# Staff Report

**Report To:** Special Meeting of Council  
**Meeting Date:** April 2, 2026  
**Report Number:** CFS.26.022  
**Title:** Value Engineering Exercise Review – Mill Street Pumping Station  
**Prepared by:** Monica Quinlan, Director of Corporate & Financial Services;  
Adam Smith, CAO

The purpose of this report is to present the findings of the Value Engineering (VE) exercise approved through [Staff Report CFS.26.009](#) and to outline a recommended path forward for the Mill Street Sewage Pumping Station (SPS) component of the Housing Enabling Water Systems (HEWS) project.

**REDUCE SANITARY LOS TO MATCH DRAINAGE SYSTEM LOS**

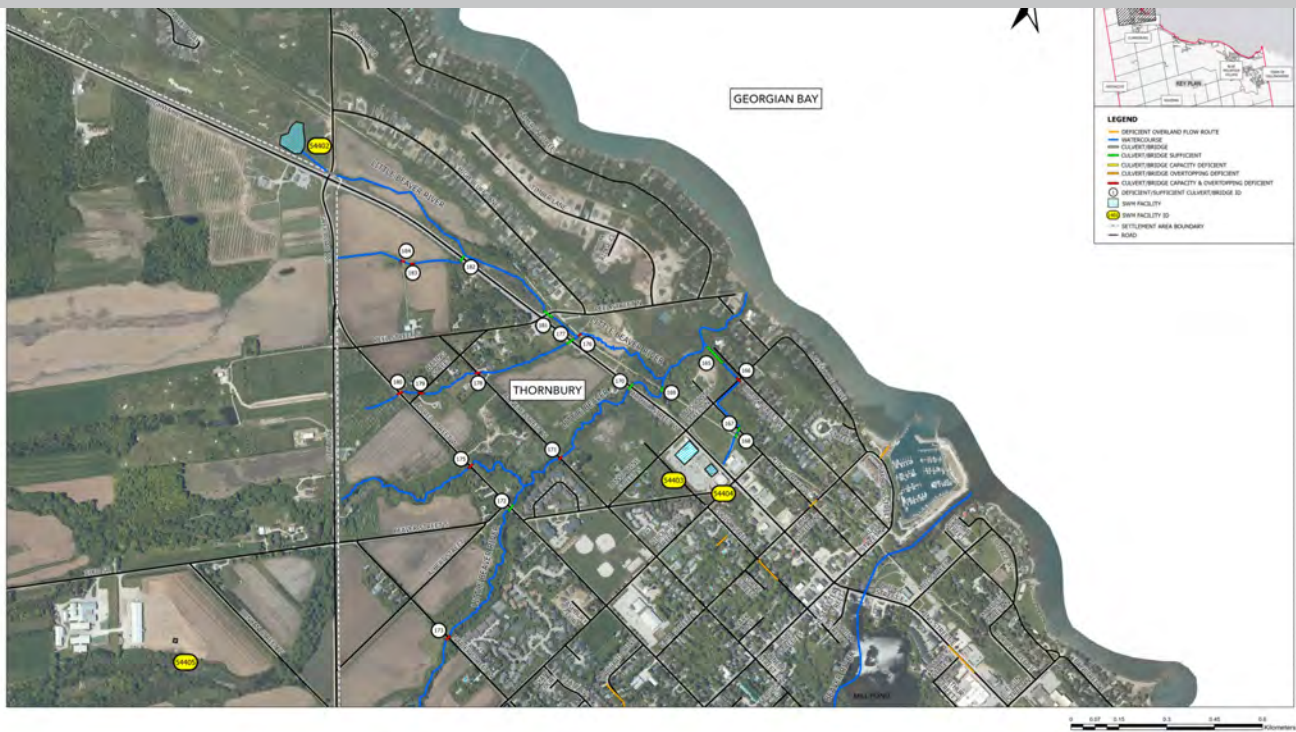
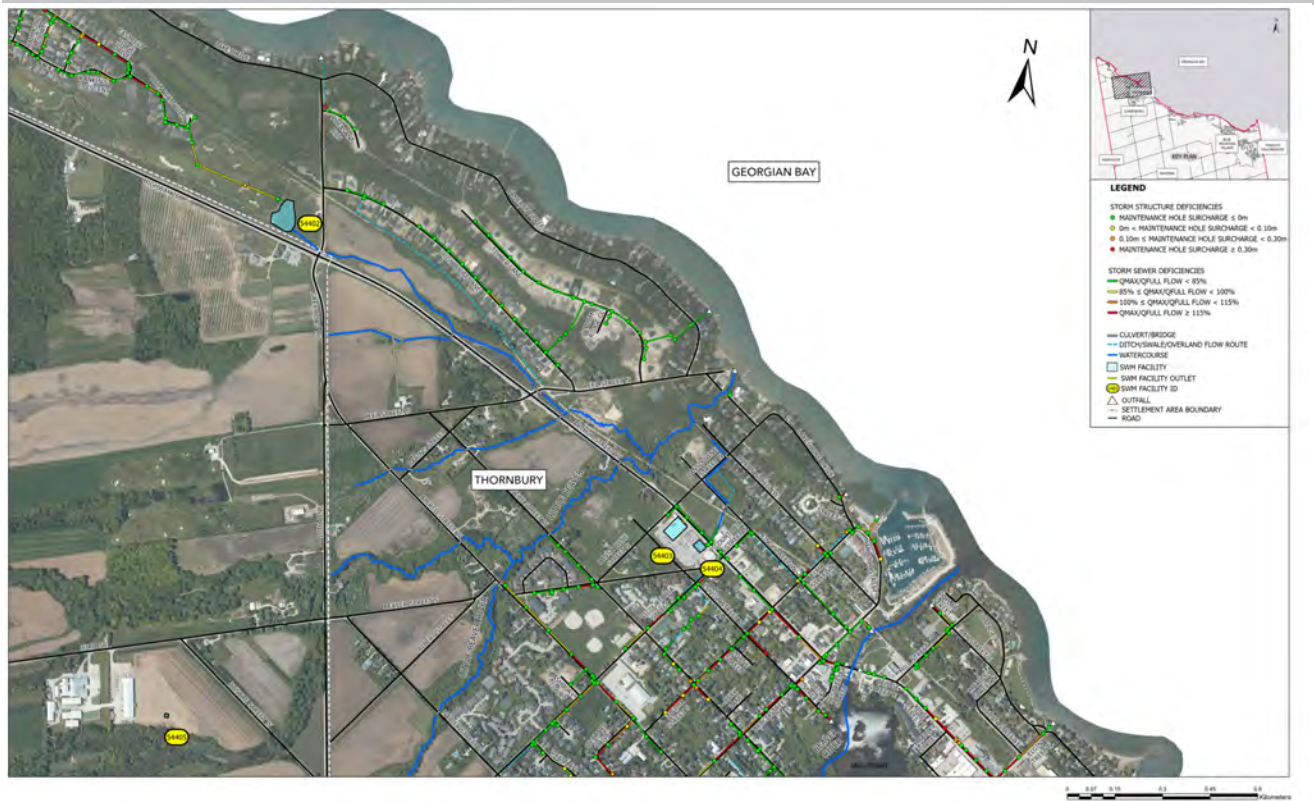
The alternative concept is to not push the LOS of the sanitary system too far ahead of the LOS of the drainage system. Otherwise, flow from deficiencies in the drainage system may find its way into the sanitary system. As additional sanitary capacity is created, additional storm flows may find their way into the sanitary sewer and show as increased I&I.

*INTRODUCE PUMP CONTROL VALVES AT PUMP STATIONS AND NO VFDS*

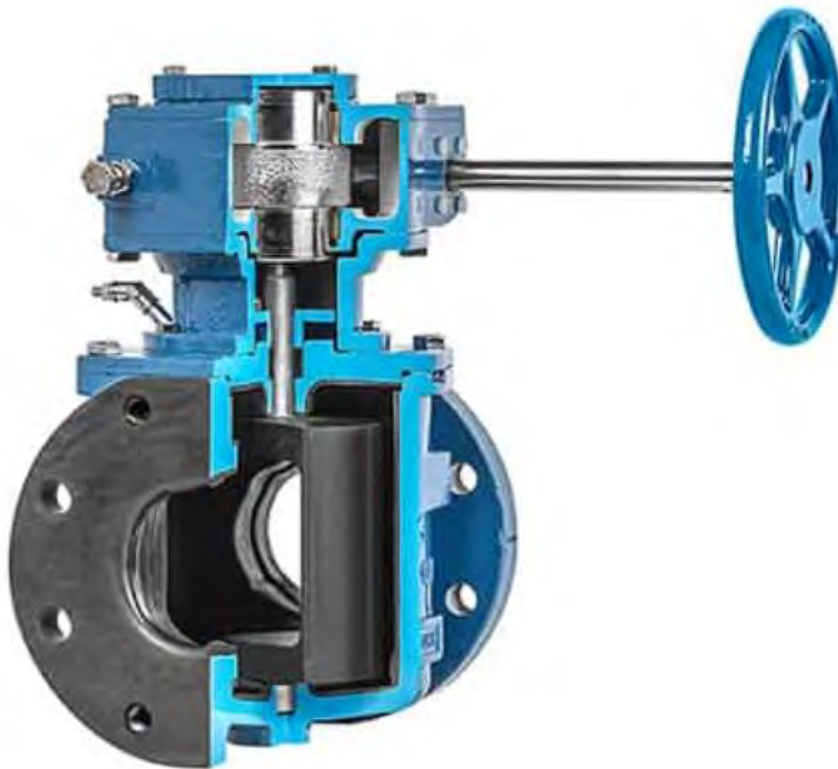
The use of actuated pump control plug valves in lieu of VFDs will provide required rangeability of flow from the station while reducing capital and maintenance cost of VFD drives. This will also allow a reduction in the condition space that will be required for the VFD drives.
